Powerlink Queensland

Request for Project Change

Report 1 – Hughenden Camp

Volume 1 – Summary Information

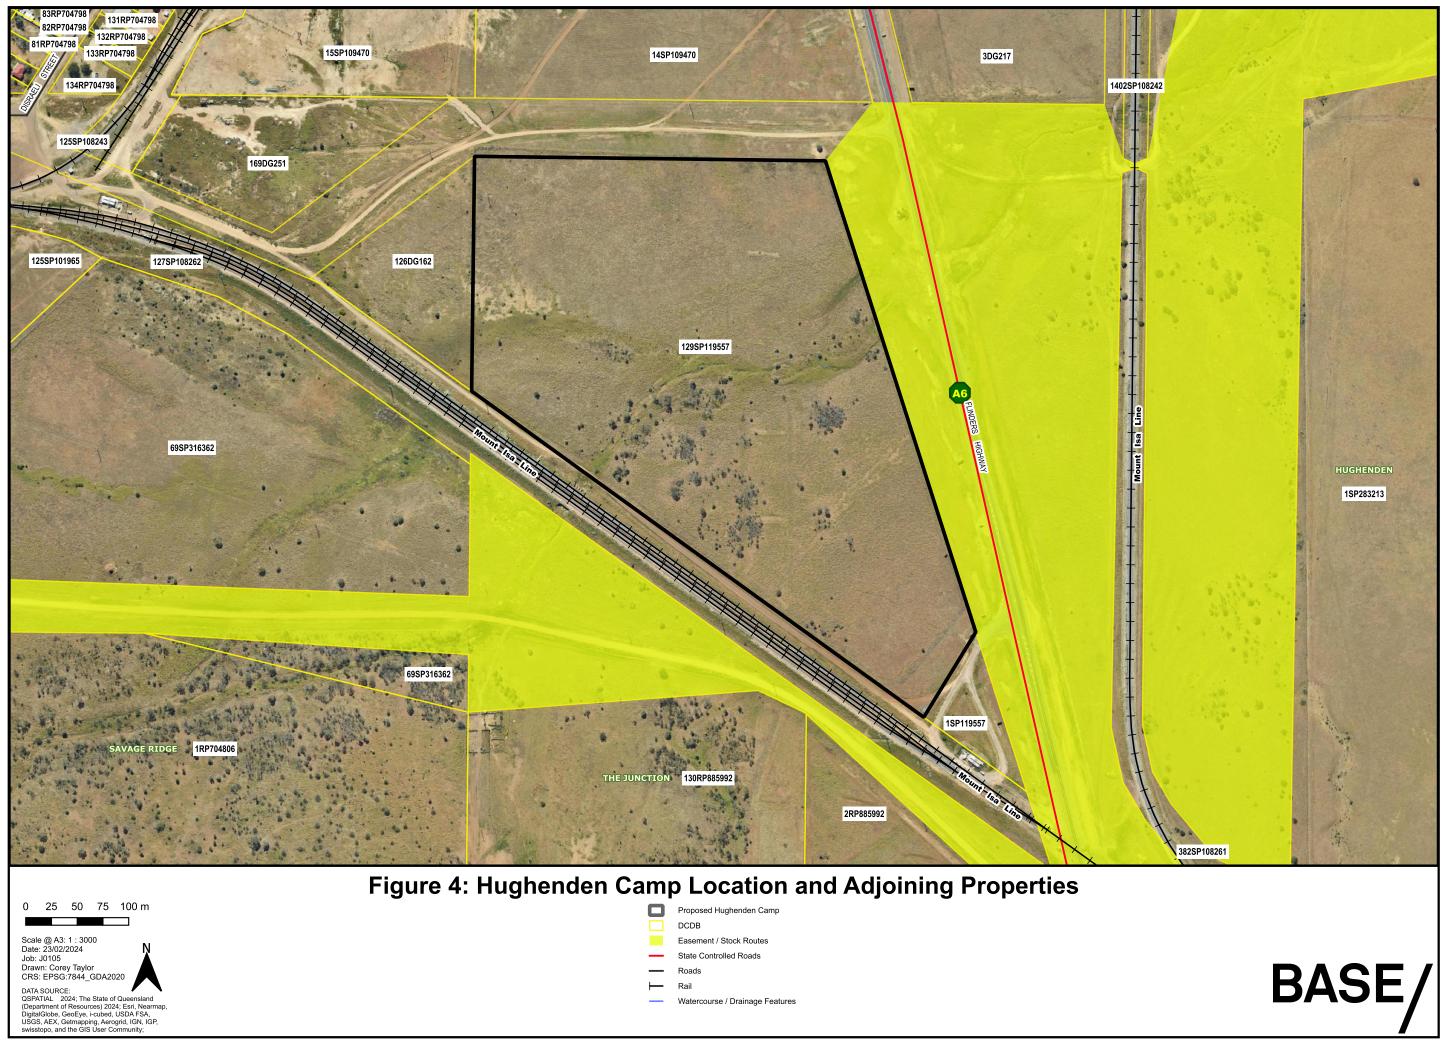
The Hughenden camp is proposed to impact lot 129 on SP119557 (refer to Figure 4 and Table 7-1)

Figure 7 Hughenden Camp Locations and Potential Flooding Impacts

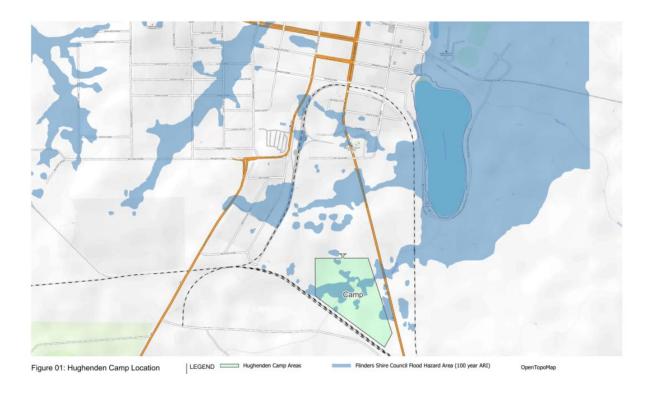
Following the release of the Coordinator-General's report on the project, the nominated camp locations at lot 156H20323, lot 24H20328, lot 29H20328 and 118DG118, as presented in Figure 3, were further reviewed in consultation with the Council and it was confirmed these locations would likely be inundated during a 100 year ARI, refer to Figure 7.

Parts of the proposed site (Lot 129 on SP119557) may be affected by Flood Hazard Areas (100-year ARI), as shown in the mapping for the Shire of Flinders Planning Scheme. Refer to Figure 01 of the Stormwater Management Plan in Volume 3, Appendix F for the Flinders Shire Council Flood Hazard Area (100-year ARI).
